DENDROBIUM COAL MINE

LONGWALL 19A SUBSIDENCE MANAGEMENT PLAN

Reasons For Decision

Figure 2: Location of Swamps, including Swamp 15a

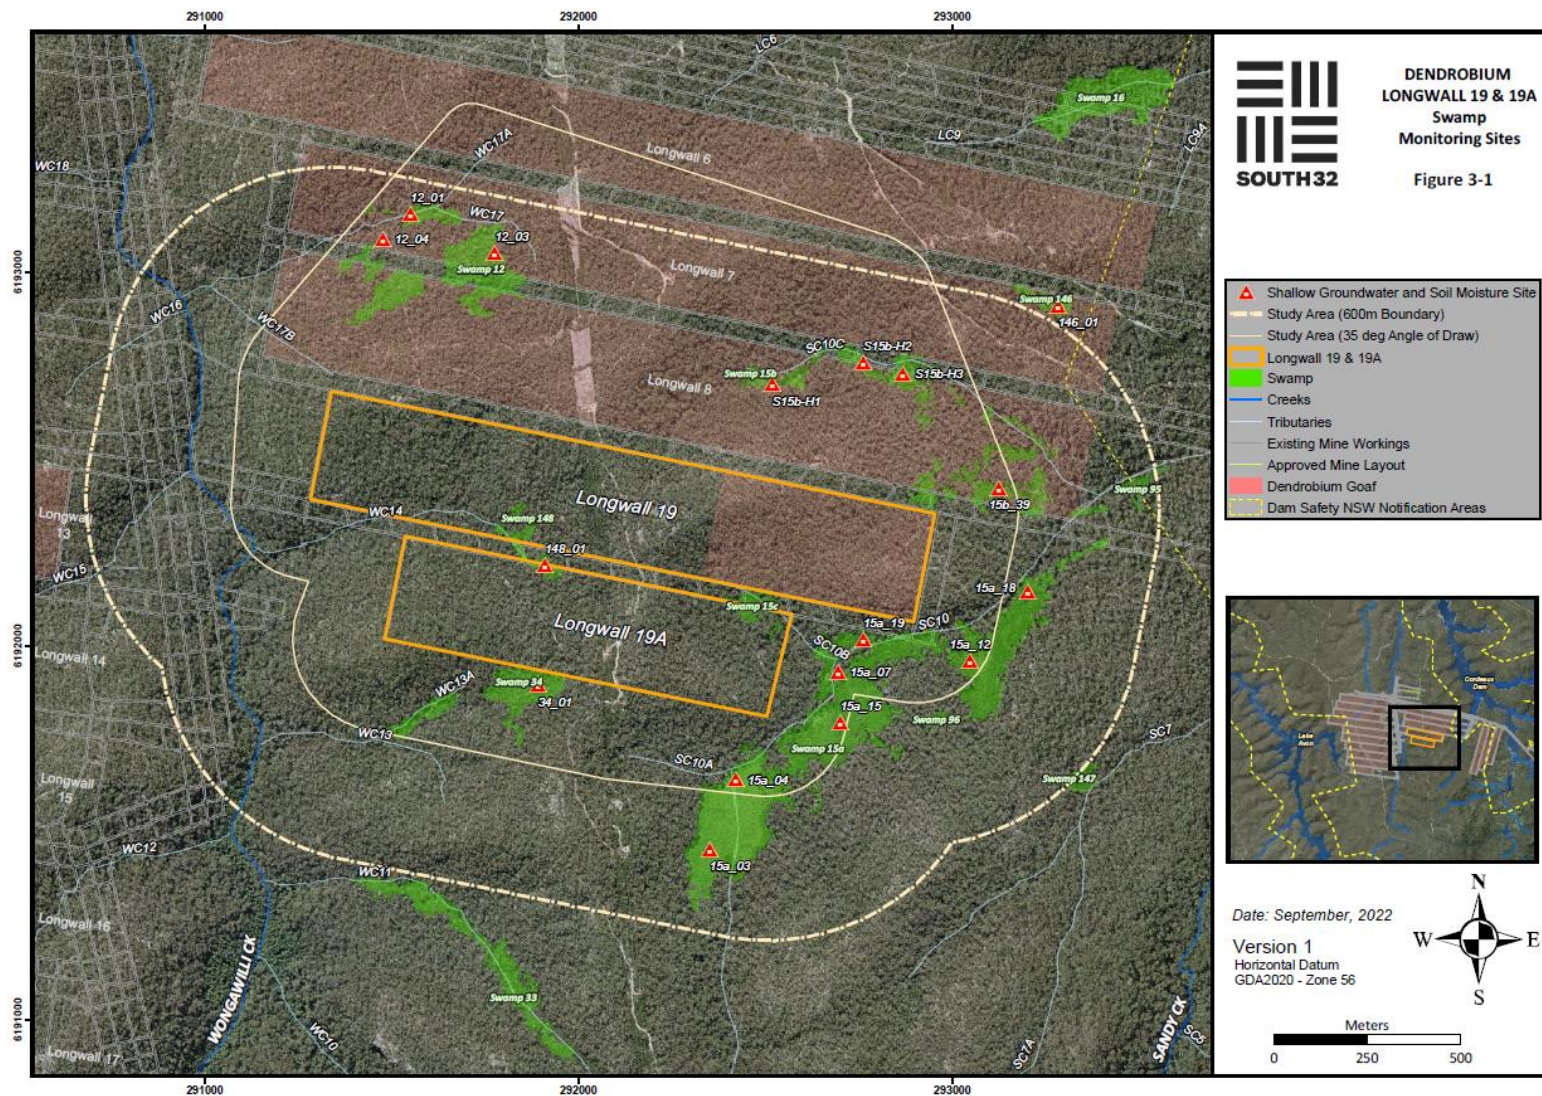
- Swamp 15a is a large upland coastal swamp (approximately 1,330 m in length and 17.38 ha in area) which is located to the east, southeast and south of the proposed LW 19A (**Figure 2**). The swamp’s controlling rock bar is a 12 m waterfall at the north-eastern, downstream end of the swamp, which is located approximately 700 m from the proposed LW 19A.

- In addition to Swamp 15a, two other swamps have been identified partially above LW 19A (i.e. Swamp 15c and 148) and 4 swamps wholly or partially within the 600 m boundary (i.e. Swamps 12, 15b, 34 and 96) (**Figure 2**).

- As discussed in detail below, based on historical and, in particular, recent monitoring results, and advice from the Panel, the Department considers that the proposed setback from Swamp 15a (i.e. 61 meters (m)) may not provide adequate protection to the “ecosystem functionality” of the swamp. The Department has therefore recommended that LW 19A be set back at least 120 m from Swamp 15a.

- Based on these findings and considerations, the Panel recommended that *“as a minimum requirement to meet Condition 5 regarding ecosystem functionality of Swamp 15a, LW 19A should be set back at a distance of, at least, 120 m from the closest edge of Swamp 15a”*. The Department accepts this advice and has recommended a condition to give it effect.
